For construction
 1-5 St Pancras Way NW1
 second floor plan
 MEPA ARCHITECTS
 10-18 Newby Street London N1 7BE
 0111010 AF 150 BC 1:020 7251 5573
 0524 2-203 1
 www.mepa.co.uk

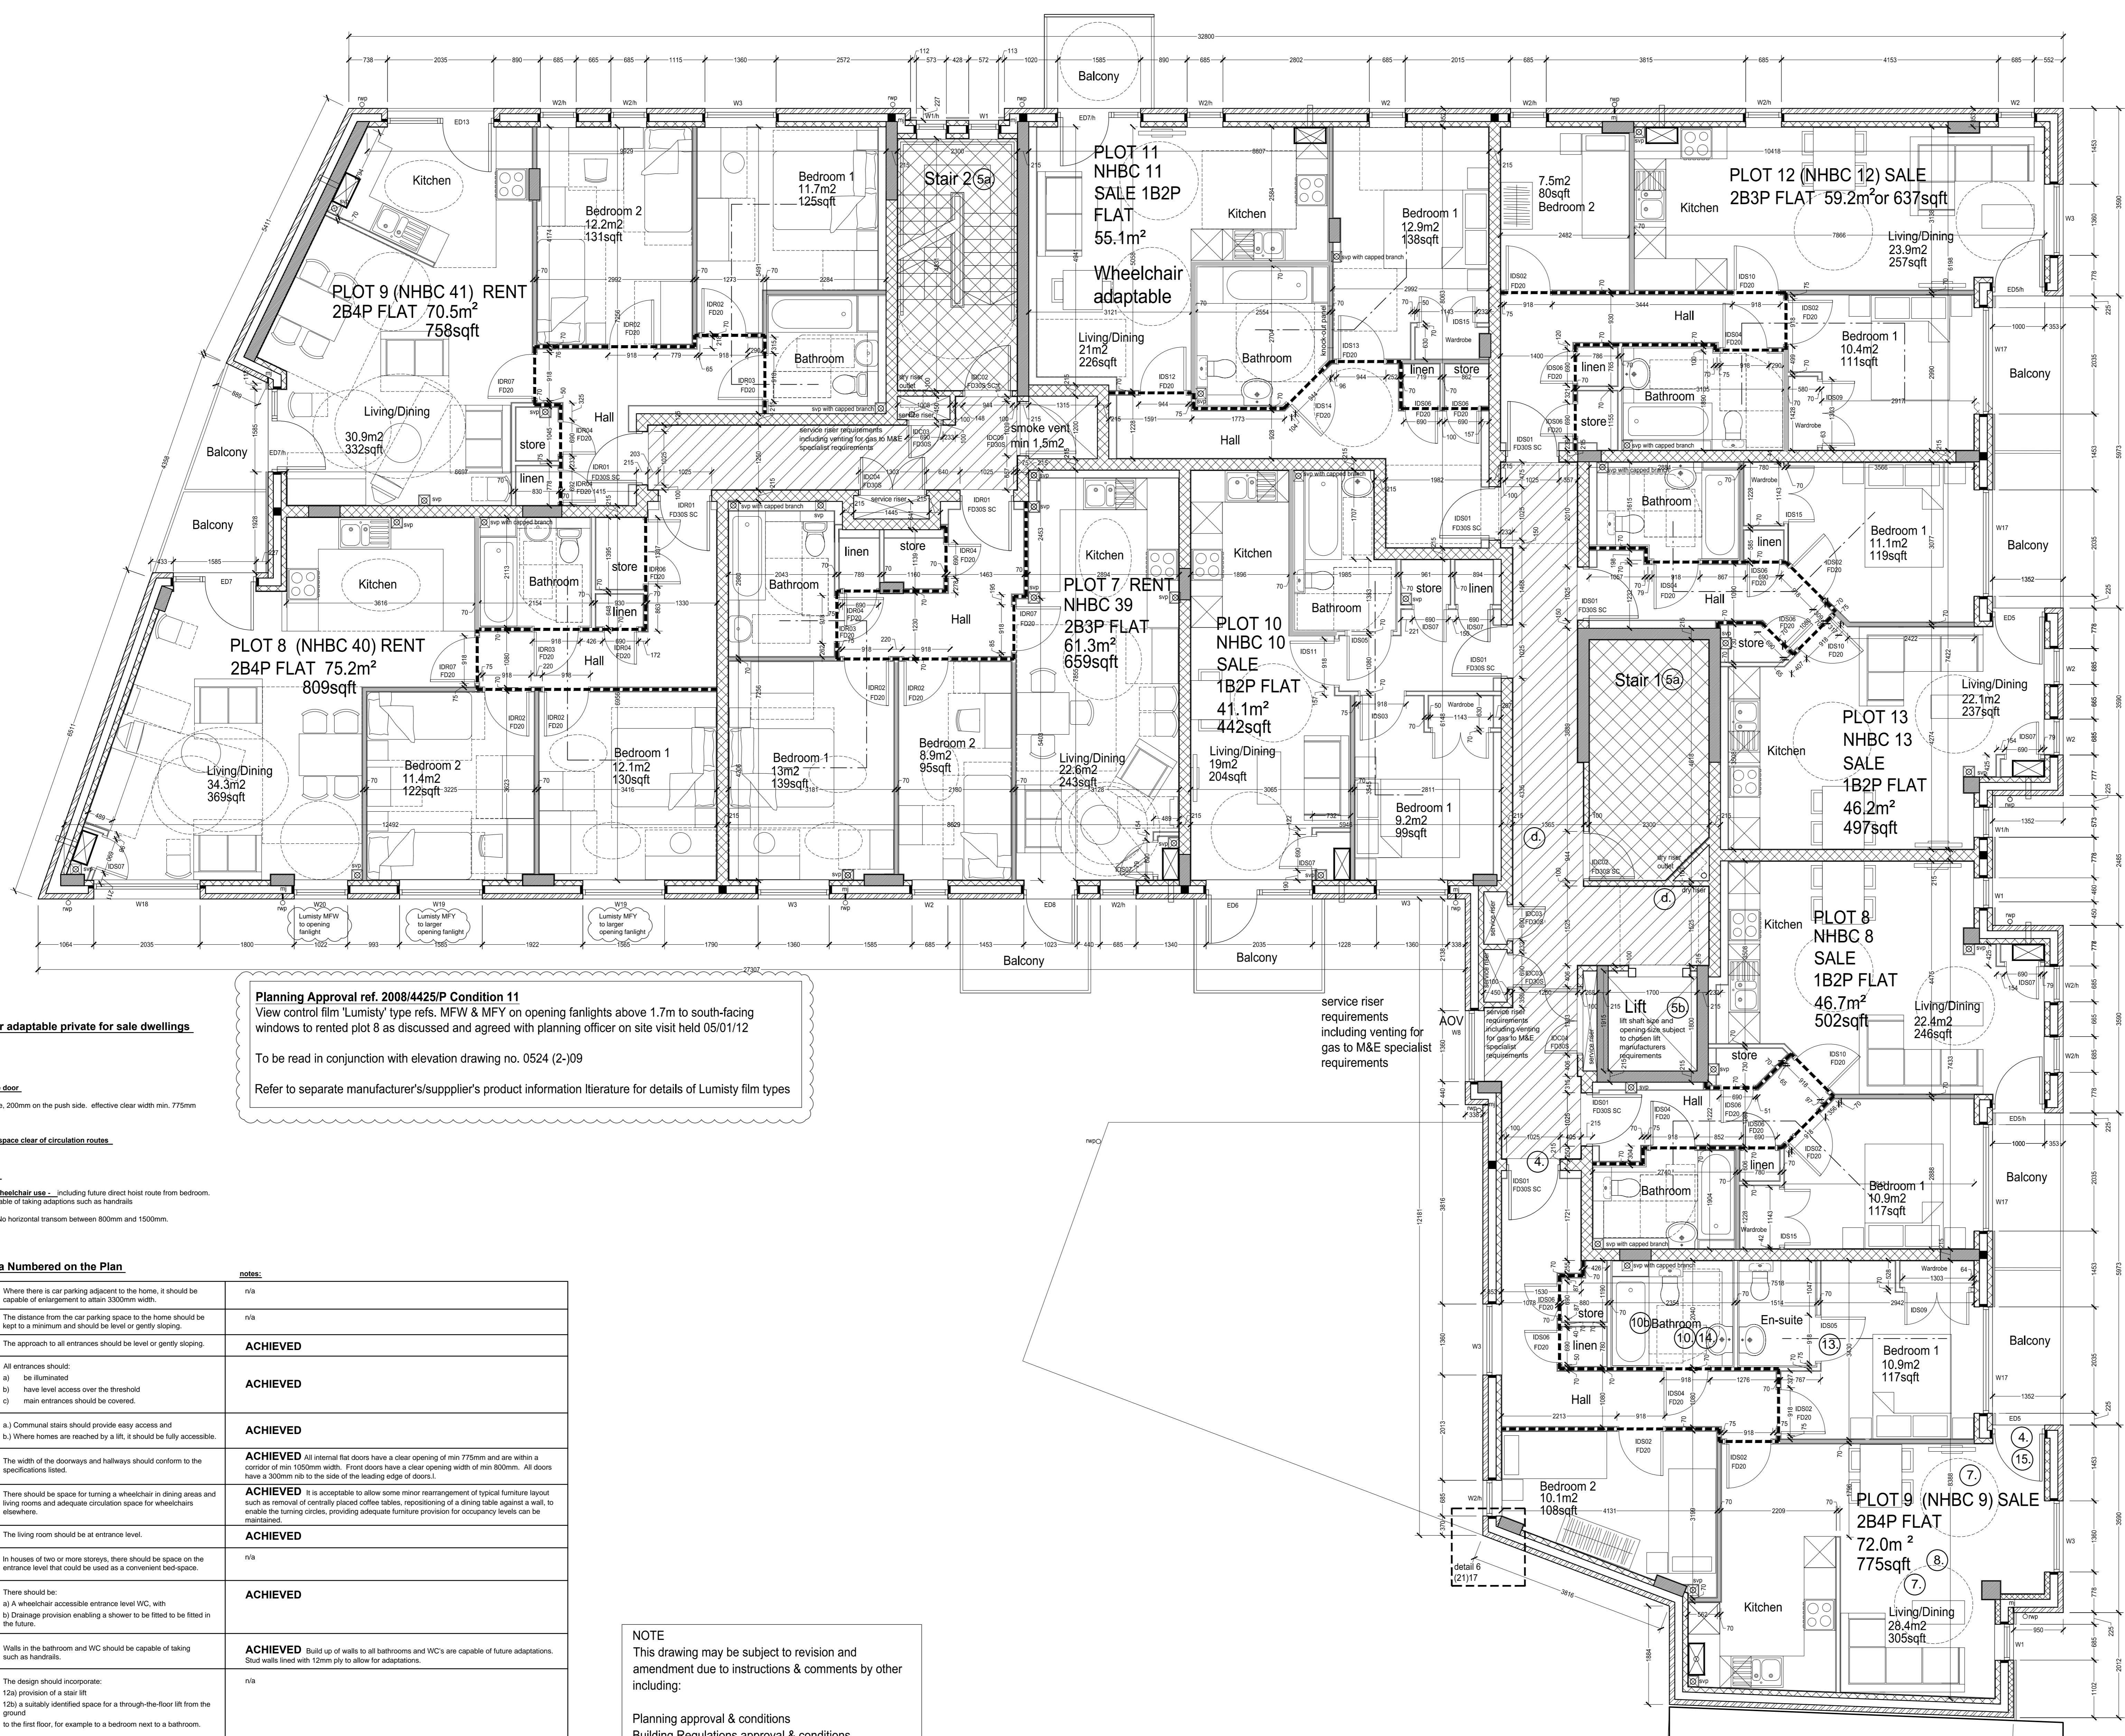
1 AF 06/01/12 location and specification of Lumisty view control film to south-facing windows to rent plot 8 shown as discussed and agreed with planning officer on site 05/01/12 af
 2 AF 04/06/11 ED09 address af
 3 AF 23/06/11 W17 positions amended af
 4 AF 13/05/11 Future floor gullies omitted. Branch caps to bathroom svps added. Riser outboard doors revised. af
 5 to 23/03/11 Room areas added. Detail refs added. Boiler cupboards added. af
 6 to 03/02/11 NHBC plot numbers added. SVPs added to plot 7. af
 7 to 27/01/11 movement joints added. SVPs added. Issued for construction. af
 8 to 02/12/10 further design development, internal dimensions and door codes added. Issued for approvals. af
 A SW 22/10/10 further design development af
 RV by site revision af
 SC status af

Planning Approval ref. 2008/4425/P Condition 11
 View control film 'Lumisty' type refs. MFW & MFY on opening fanlights above 1.7m to south-facing windows to rented plot 8 as discussed and agreed with planning officer on site visit held 05/01/12
 To be read in conjunction with elevation drawing no. 0524 (2-09)
 Refer to separate manufacturer's/supplier's product information literature for details of Lumisty film types
